MODIFICATION #3 – Option B (Alternative Condition)  
MODIFIED SECTION FROM PROJECT BOUNDARY TO WESTERLY ROUNDABOUT (W/ TRANSITION)

**Request for a  
Modification to a Road Standard  
and/or Project Conditions**

**Project Number:** TM 5571/5572 **Date of Request:** August 5, 2015

## LILAC HILLS RANCH: 2.2C LIGHT COLLECTOR MODIFICATION TO ROAD STANDARDS

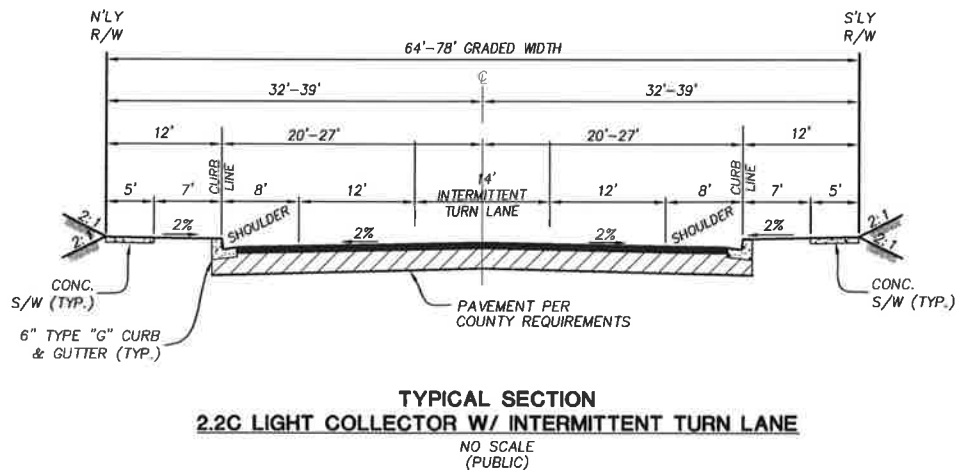
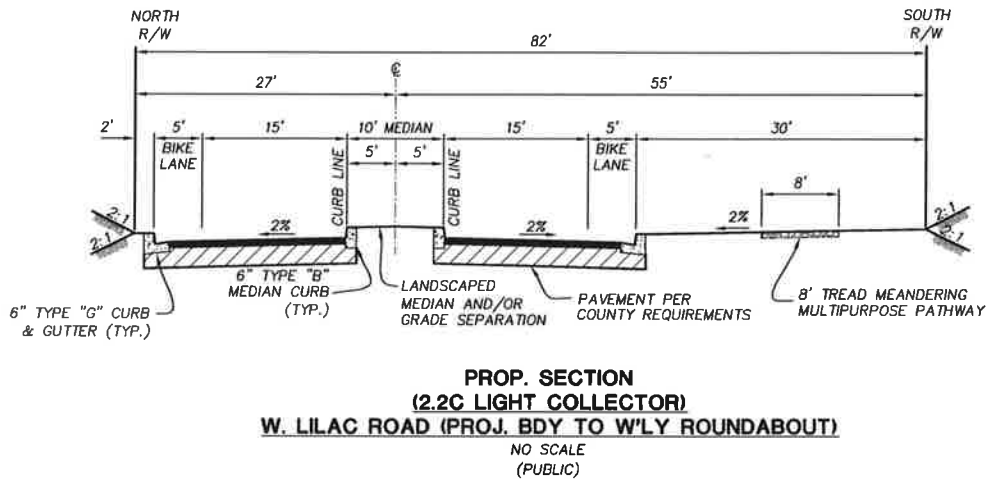
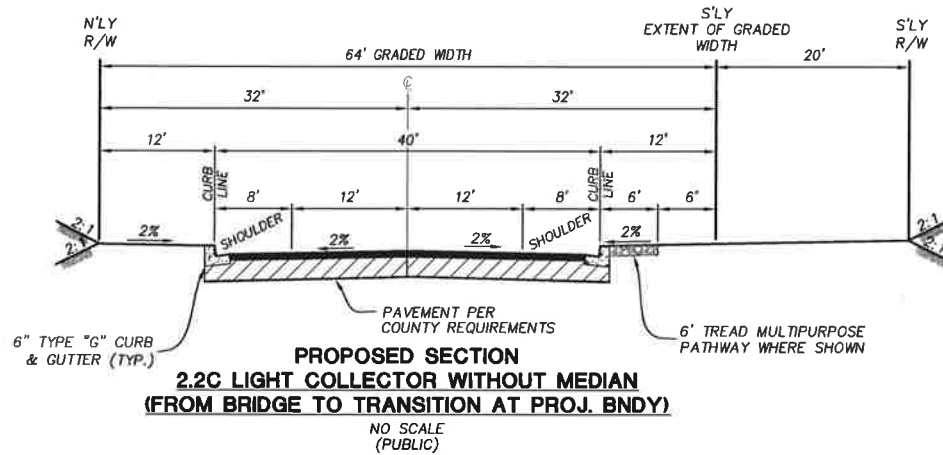
**Requested Modification (attach engineering sketches showing existing layout, details, and notes):** The standard road section for Light Collector Road 2.2C with an intermittent turn lane has a 54' wide curb to curb width on 78' ROW (64' with no turn lane), 8ft shoulders, and 12' pkwys. The requested modification to the road standard is to decrease the pkwy to a 2' pkwy along the north, add a proposed 10' raised median with 20' of pavement and increased 30' pkwy with 8' meandering multi-purpose trial along the south. West of this modification, the road section consists of the standard for 2.2C Light Collector without an intermittent turn lane, having 40' wide curb to curb width on 64' ROW, 8' shoulders, and 12' parkways. The modification request includes a transition from this typical section to the proposed, non-standard 2.2C Light Collector east of the subdivision boundary. The 320' transition safely handles the reduction of the northern pkwy from 12' to 2' and the introduction of a median.

**Reason for Modification (provide attachment if additional space is required):** The existing topography on each side of the existing graded road width is very steep in this area. Extensive off-site grading and habitat disturbance as well as the need for off-site condemnation to obtain off-site ROW. Permission to grade from adjacent land owners on both sides would be required to implement the standard roadway section (Light Collector 2.2c). West Lilac would operate at LOS D or better with or without the requested modification. The modification would provide enhanced landscaping with the median and 30' wide southerly parkway through the project. The proposed median acts as a splitter for the proposed roundabout.
